Subject: MHI's Response to US-APWR DCD RAI No. 322-1999 (45-day response)

Response to Request for Additional Information No. 322-1999,
Revision 0 (45-day response)

US-APWR Design Certification

RAI NO.: NO. 322-1999 REVISION 0

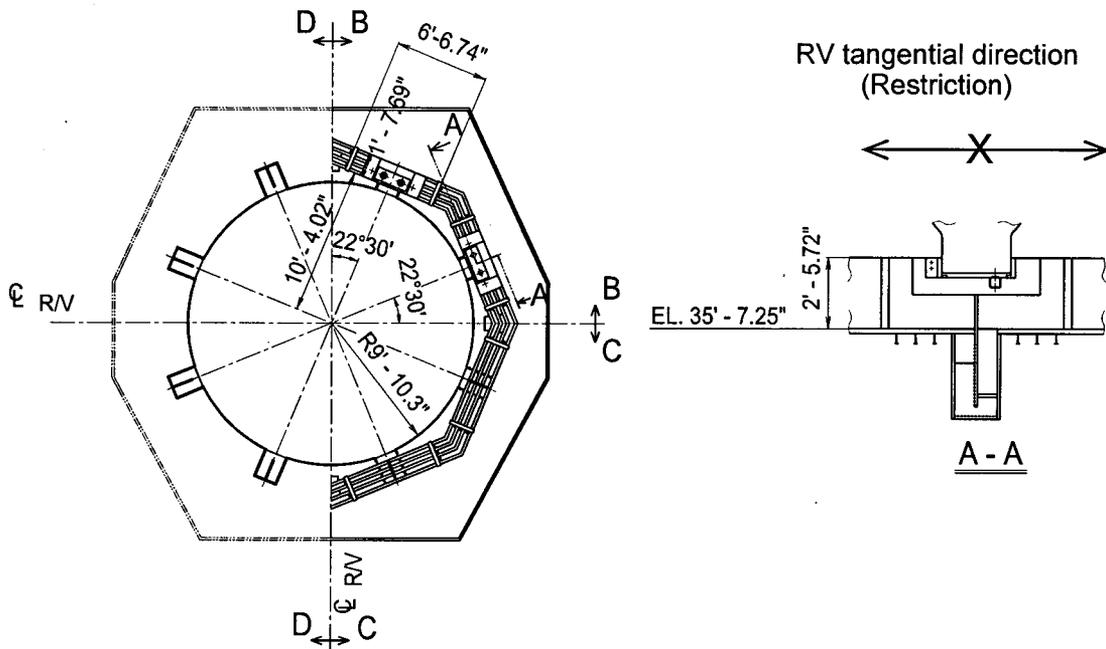
In DCD Subsection 3.8.3.1.1, the paragraph (Page 3.8-31) states "The supports are formed by sliding surfaces between the shim plates and support pads to allow radial thermal growth of the RCS and RV. The vessel position is maintained unchanged by controlling the horizontal load through the support brackets and the base plate."

- (b) Describe how the control of the horizontal load through the support brackets and the base plate is accomplished such that the vessel position is unchanged while allowing radial thermal growth.
- (c) How is the RV modeled in the seismic analysis? Was the rocking mode of vibration of the RV included in the model?

- (a) The sliding support pads and shim plates are made of metallic materials only. No non-metallic materials will be used for sliding support pads.
- (b) The Reactor Vessel (RV) supports of US-APWR are located at the RV outlet and inlet nozzles, eight locations as shown in figure below. The RV support allows radial displacement of the RV, but does not allow tangential displacement of the RV, as shown in section A-A of the figure. When a horizontal load acts on the RV, the RV support in the tangential direction of the RV will restrict the displacement of the RV.

- (c) The RV is modeled by a vertical single beam, which is corresponding to the center axis of the RV, since it is cylindrical and isotropic. The mass of the body and the internal water is applied to the

In the model, virtual rigid bars are connected from the vertical single beam of the RV to the support points of RV nozzles. The horizontal and vertical spring elements are attached to the rigid bars at the RV support points. Therefore, the rocking and translation movements have been considered in the RV model.

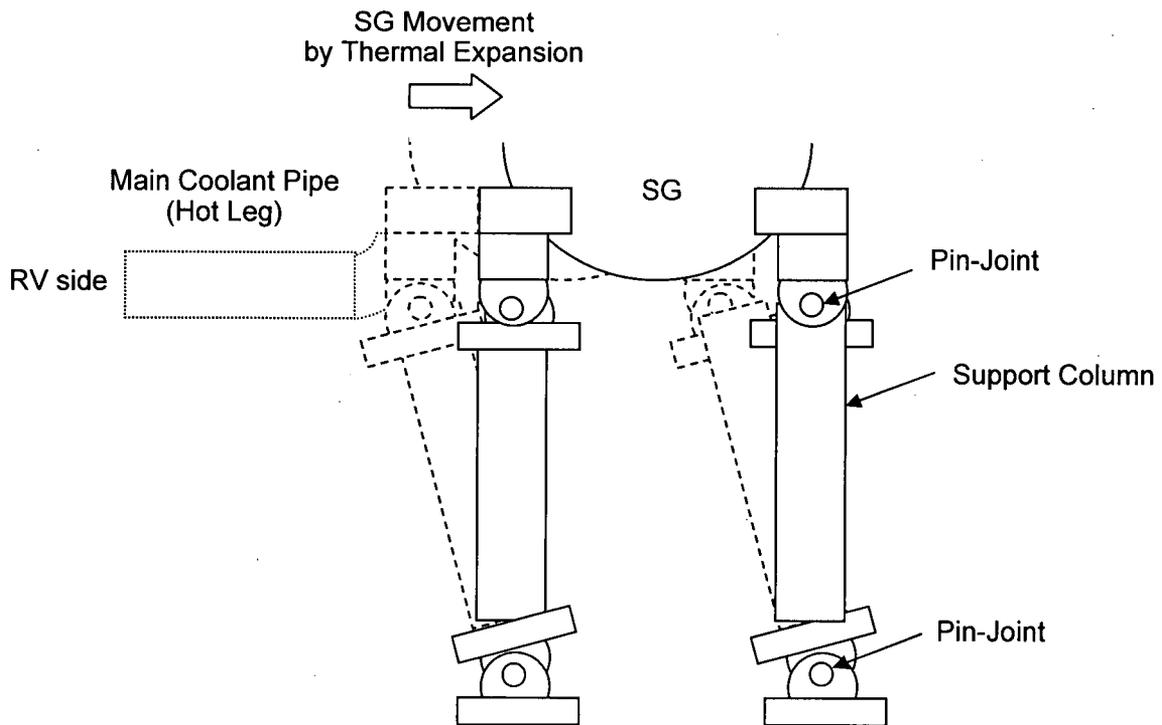
In DCD Subsection 3.8.3.1.2, the third paragraph (Page 3.8-31) states "The upper and lower ends of the columns are pin-jointed to permit movement of the SGs caused by thermal expansion of piping. Figure 3.8.3-2 depicts the SG support system."

- (a) Provide the rationale for selecting the number and location of the lateral supports for the steam generators.
 - (b) Use of a pin-joint allows free rotation but does not allow displacement to take place. Provide information that shows clearly how the pin-joints permit movement of the SG caused by thermal expansion of piping that is attached to the SG.
-

- (a) In order to reduce the seismic responses of the US-APWR Steam Generators (SG), a three level lateral support system is designed as shown in the US-APWR DCD Figure 3.8.3-2. The SG support system consists of an upper shell support, an intermediate shell support, and a lower

lateral support. The upper and intermediate shell supports are lateral restraints (snubbers), while the lower support is constructed of steel. This three level support system has increased the natural frequency of the SG vibration mode compared to the two level support system. And this support system of SG shows the excellent response reduction effects for earthquake conditions. This response is described in detail in Subsection 3.7.2.4.

- (b) The support columns of steam generator will be set up considering the thermal expansion movement of the hot leg and SG that is calculating at 100% power operation. The upper end pin-joint of the support columns toward the lower end pin-joint of support columns will be set to the position based on calculated thermal expansion caused by hot leg and the SG-to-hot leg direction. Therefore, support columns will be set to tilt to the RV side slightly, the set of support column pin-joints, upper and lower, will not restrict thermal expansion displacement of SG as shown in figure below.

Figure 3.8.3-7 Typical Details of SC Modules
(Sheet 2 of 5)

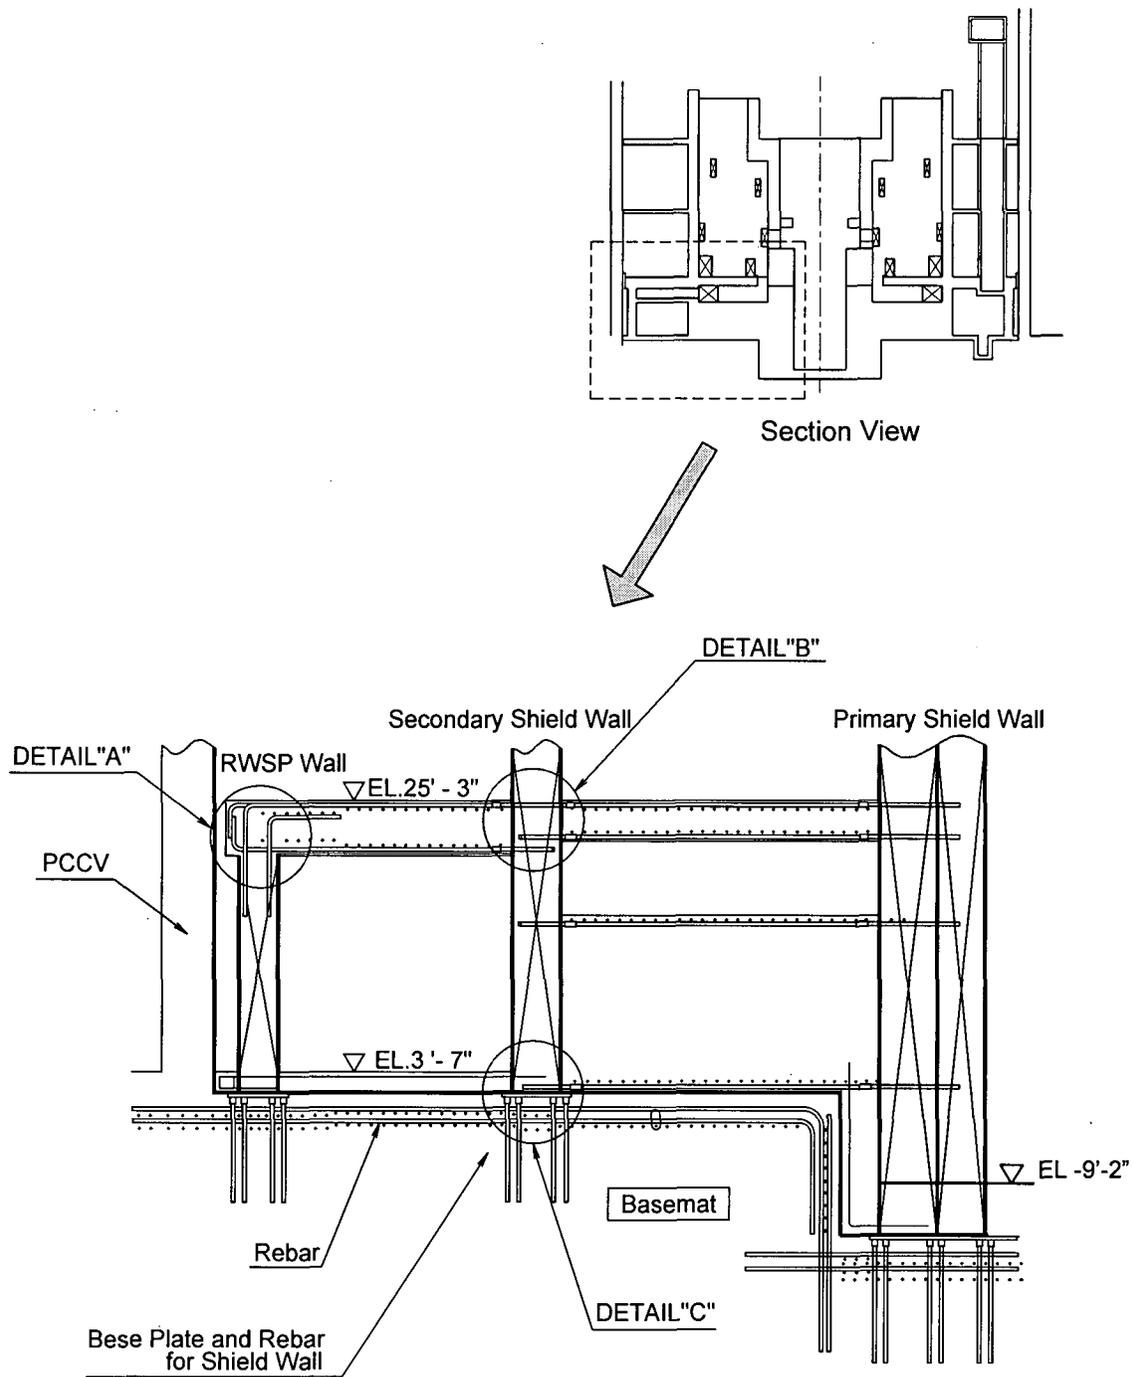
In Sheet 2 of 5 of DCD Figure 3.8.3-7 (Page 3.8-185), the elevation of 9'-2" marked on the structure is lower than the mark on the structure for the elevation of 3'-7".

The applicant is requested to provide clarification, or correct this apparent error.

The correct elevation should be -9'-2".

- Change Figure 3.8.3-7 (Rev. 1, page 3.8-185) to read: "-9'-2"
